UNITED STATES PATENT AND TRADEMARK OFFICE

APPLICATION NO.	FILING DATE	FIRST NAMED INVENTOR	ATTORNEY DOCKET NO.	CONFIRMATION NO.
10/790,217	03/02/2004	Akira Yoneoka	P21-163407M/NY	9855
21254	7590	06/21/2006	EXAMINER	
MCGINN INTELLECTUAL PROPERTY LAW GROUP, PLLC 8321 OLD COURTHOUSE ROAD SUITE 200 VIENNA, VA 22182-3817			MITCHELL, KATHERINE W	
			ART UNIT	PAPER NUMBER
			3677

Office Action Summary

DETAILED ACTION***Continued Examination Under 37 CFR 1.114***

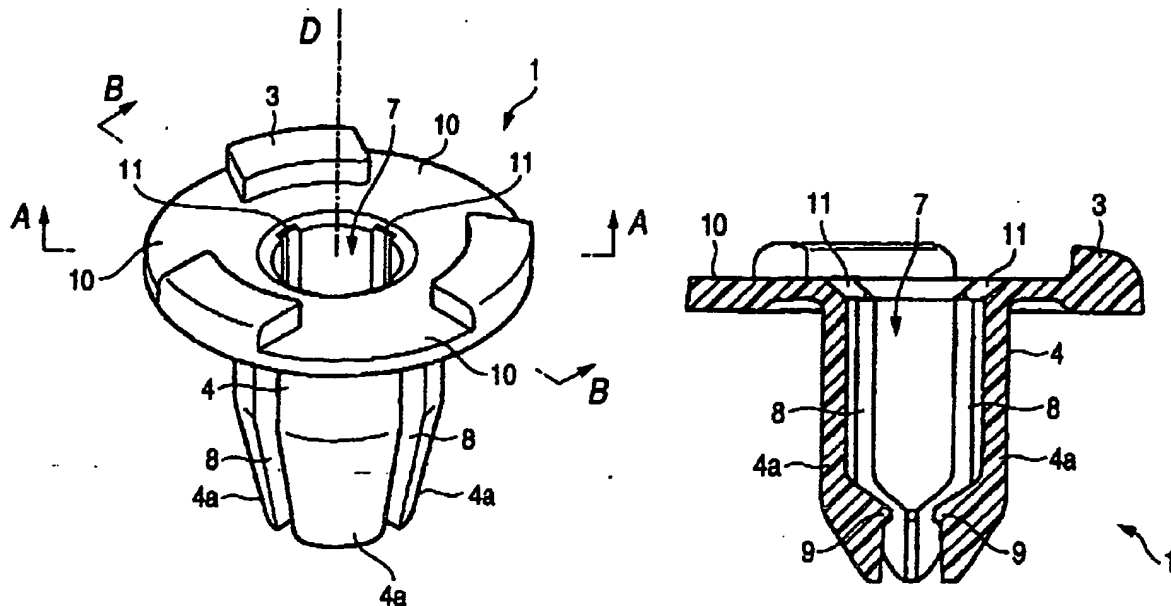
- o The figures show rib walls 12 on pins, so the projection is assumed to be on the grommet. Spec discloses projections 11, shown as recess, not projection. Is applicant considering a recess to be a –hole projection–, which is contradictory to the accepted meaning of projection. Where applicant acts as his or her own lexicographer to specifically define a term of a claim contrary to its ordinary meaning, the written description must clearly redefine the claim term and set forth the uncommon definition so as to put one reasonably skilled in the art on notice that the applicant intended to so redefine that claim term. *Process Control Corp. v. HydReclaim Corp.*, 190 F.3d 1350, 1357, 52 USPQ2d 1029, 1033 (Fed. Cir. 1999). The term is indefinite because the specification does not clearly redefine the term.

Examiner cannot comprehend what applicant is trying to describe or claim.

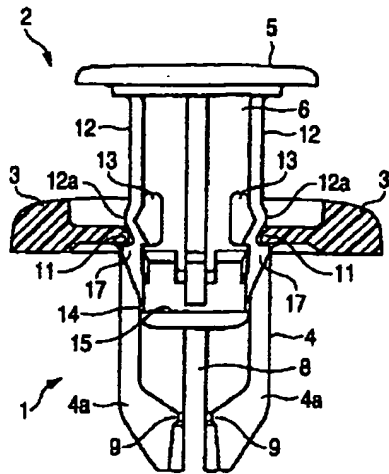
How projection "11" correlates in Figs 1, 2A and 4 above, with the specification and claim 17 is unclear. Applicant should explicitly clarify.

FIG. 5

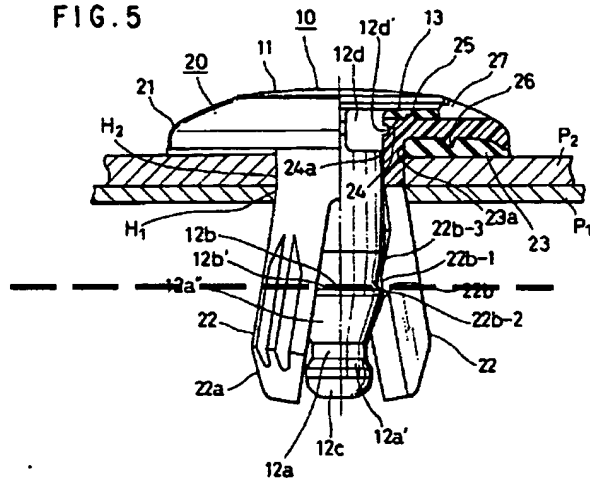
Re claim 1: Ueno OR Anderson OR Plimi Jr teach a jointing member comprising a grommet and pin. The grommet has a flange and leg portions, capable of being opened, and there is an insertion hole in the center of the flange to an inner portion of the leg. There is an engagement portion on the leg portion. The pin includes a head and shaft, said shaft insertable in the insertion hole of the grommet, the shaft has an

engagement surface and a lock surface each engageable with the engagement portion.

The distance from the grommet flange to the grommet leg portion tip is greater than a

distance from the pin head to the pin tip.

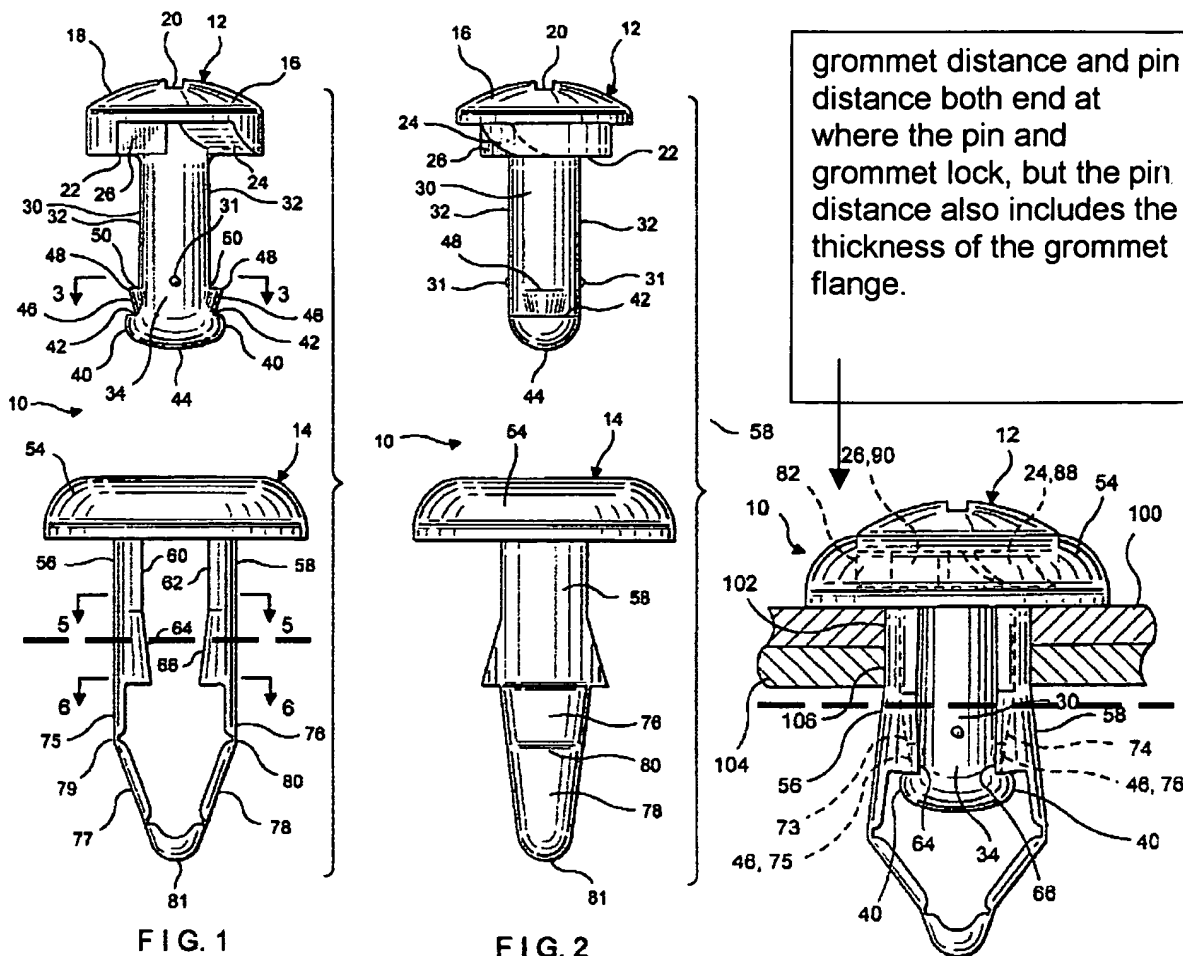
Re claim 12; The engagement portion comprises a protruding portion extending from the leg inner surface - see Fig 1 and 9.

Re claim 13: There are a plurality of slits (best seen Fig 1 – between leg portions 77,78, in the grommet dividing the leg into a plurality of leg pieces.

Re claim 14: Anything below the dashed line by examiner is considered where an expanded tip end side of the leg begins. Note that Fig 9 shows how this section expands when inserted. The engagement portion is formed on the inner surface of this tip end side.

Re claim 21: The distance from the grommet flange to the grommet engagement portion is smaller than the distance from the pinhead to the pin lock surface (best seen in Fig 9)
